Applicant:	Aeon VP Bloomington, LLC (Owner and Developer)
Location:	1900 East 86 th Street
Request:	<ol style="list-style-type: none">1) Rezoning from R-4 Multiple-Family Residential to RM-24(PD) High Density Residential (Planned Development).2) Preliminary Development Plans and Final Development Plans to add 172 new residential units in two four-story multi-family residential apartment buildings to an existing multi-family residential site.
Existing Land Use and Zoning:	Multiple family residential – apartments; zoned R-4 Multiple Family Residential
Surrounding Land Use and Zoning:	North – Hotel and office; zoned C-4(PD) South – Single-family residential; zoned R-1 East – Townhomes and fire station; zoned R-4, R-4(PD) and R-1 West – State Highway 77
Comprehensive Plan Designation:	High Density Residential

PROPOSAL

Case PL2020-69

Project Description: Rezoning from R-4 to RM-24(PD), Preliminary Development Plans, and Final Development Plans to add 172 new residential units in two four-story multi-family residential apartment buildings to an existing multi-family residential site.

Figure 1: Rezoning from R-4 to RM-24(PD)

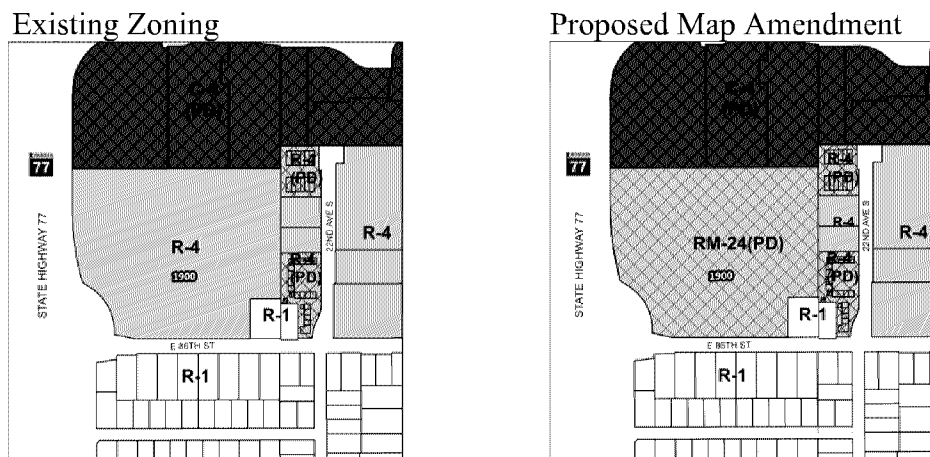
To allow for the expansion of the existing multi-family residential development, the applicant requests rezoning the property from R-4 to RM-24(PD), as shown in Figure 1. The total number of dwelling units proposed would comply with the maximum density restrictions of the RM-24 zoning district when factoring in density bonuses permitted within the Opportunity Housing Ordinance (Sec. 9.16). The maximum density allowed in the RM-24 zoning district is 24 units per acre. Given the site area of 17.67 acres, a typical residential development could have a maximum number of 424 units or dwellings under the RM-24 zoning designation. However, the OHO would allow 138 bonus dwelling units above the maximum density as a result of the affordable units provided. More information about this calculation can be found in the Opportunity Housing Ordinance section that follows. As a result, this site could have 568 dwelling units based upon the quantity of affordable units proposed. The proposed quantity of 478 apartments would be compliant with the RM-24 base zoning designation in light of the OHO density bonus tool.

To evaluate the public benefit associated with the requested zoning change, staff references the Comprehensive Plan to verify the proposed project is consistent with the City’s land use and housing goals. The Comprehensive Plan Housing Element encourages development of multi-family housing on sites near transit, services, amenities and employment. In addition, the Housing Element supports the development of life cycle housing. New multi-family residential development is a critical component of the diverse housing stock needed to achieve life cycle housing in the community. Both the Comprehensive Plan and the One Bloomington Strategic Plan also support the creation of additional affordable housing. The proposed rezoning supports multiple goals of the Comprehensive Plan and Strategic Plan and will benefit the public. Staff recommends approval of the request to rezone the property from R-1(PD) to RM-24(PD).
